Date Issued :	April 21, 2022	PCN Number :	511593
Reason for Change :	Change Supplier		
Description of Change :	Supplier change due to discontinuation of the previous supplier, as a result the part will be produced by new enlisted supplier.		
Assessment of Change :	First Article Inspection		
Planned Implementation Date :	October 24, 2022		
Sample Availability Date:	October 05, 2022		
Internal Molex Qualification Date :	October 05, 2022		
Last date to request Samples by Customer :	April 30, 2022		
Traceability Code Markings / Date :	No special marking on the product or packaging

Overview

Before Picture

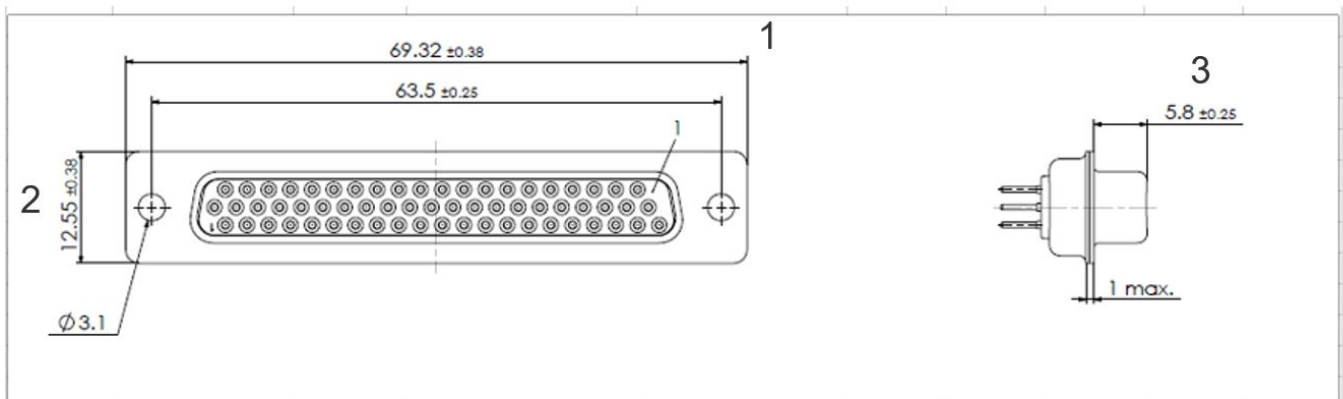
- As the current supplier has discontinued the supply of the part, the same is now being supplied from another enlisted supplier
- Product fit is being impacted as shown in slide 1
- Please find impacted Product list
- Qualification Reports and samples available upon request after the date shown above

Sr.Nr.	Parameter	Unit	Before	After
1	Dimension	mm	69.4	69.32 ± 0.38
2	Dimension	mm	12.5	12.55 ± 0.38
3	Dimension	mm	6	5.8 ± 0.38
